**Technical Service
Information Bulletin**

ECM CALIBRATION: SHIFTING ENHANCEMENT

'04 RX 330

TRANSMISSION & CLUTCH
TC005-03

Figure 1. Location of Authorized Modifications Label on 2004 RX 330

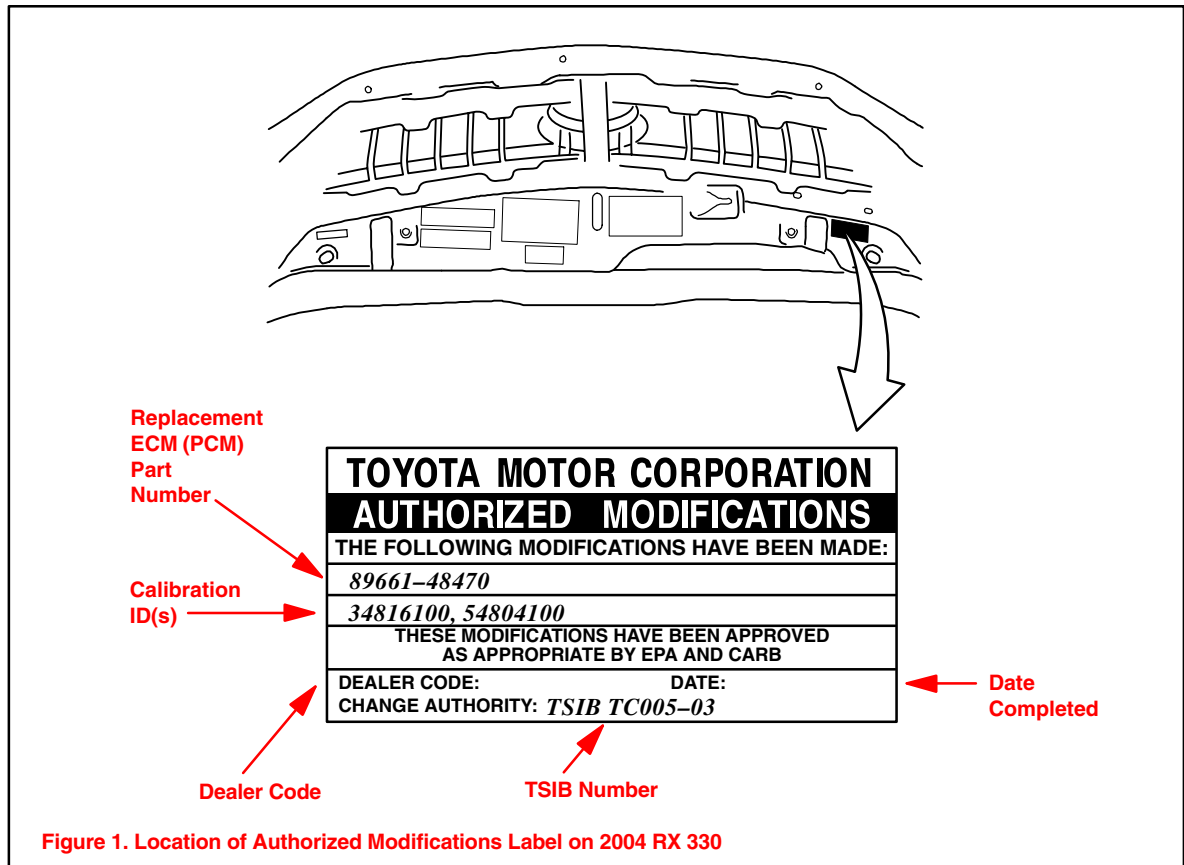
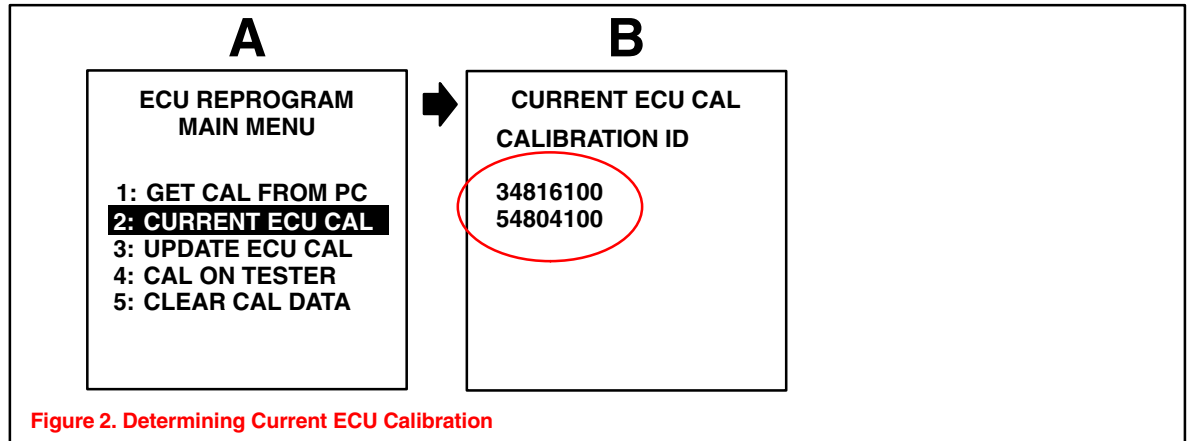
1. Check for the Authorized Modifications Label affixed to the vehicle in the location shown in Figure 1. Confirm if ECM (PCM) calibration has been updated. If not latest ECM (PCM) calibration – go to step 2.

- Start the engine and warm it up to normal operating temperature before test-driving.
- Test drive vehicle to confirm proper vehicle operation.
- Enter the required information on the Authorized Modifications Label and affix it to the vehicle at the location shown in Figure 1 (page 2). The Authorized Modifications Label is available through the MDC, P/N 00451–00001–LBL.
- Calibration update is complete.

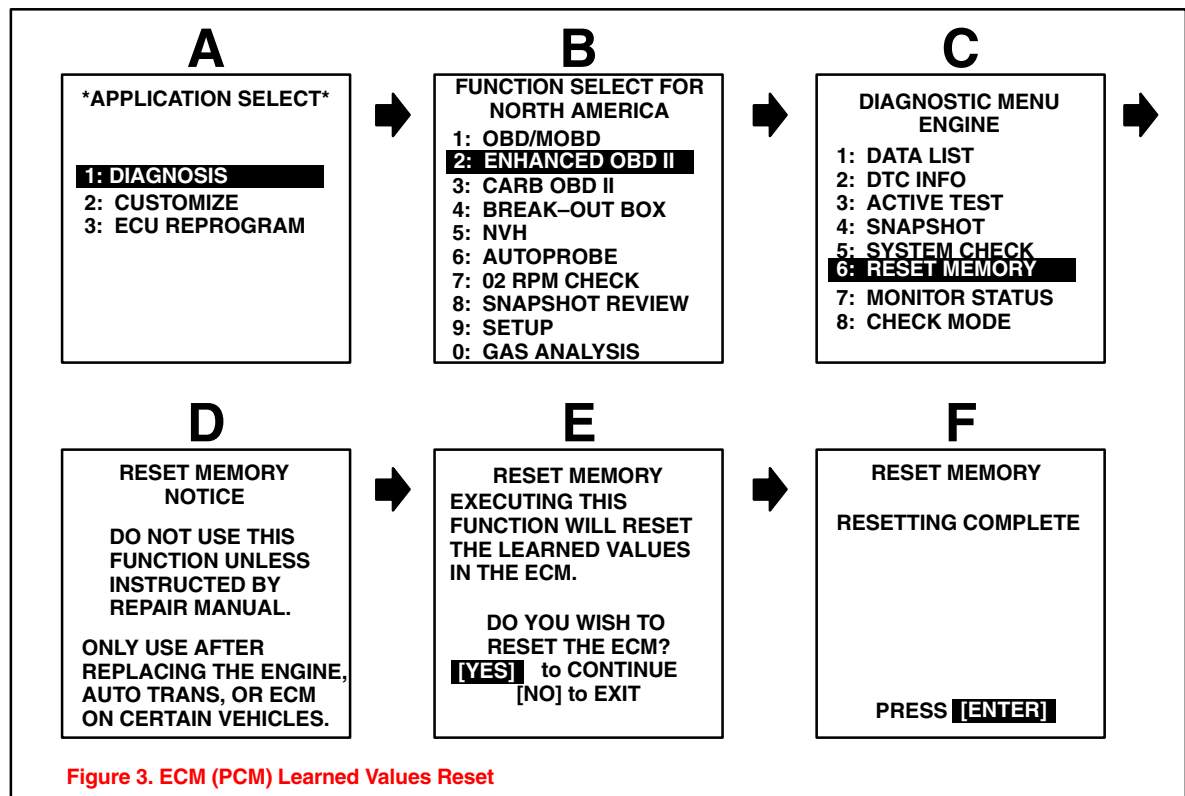
2. Connect the Diagnostic Tester to the vehicle and select CURRENT ECU CAL from the ECU REPROGRAM MAIN MENU. Determine the vehicle's current ECU calibration (see Figure 2).
 - The sample screen prints seen below are the 10.1a software version, and may differ from subsequent software versions.

- If Calibration ID matches “Previous Calibration ID” as shown in Calibration Identification Chart on page 2, proceed with flash reprogramming.
- If Calibration ID matches “New Calibration ID” as shown in Calibration Identification Chart, this vehicle has already been programmed. Refer to Repair Manual for diagnosis.
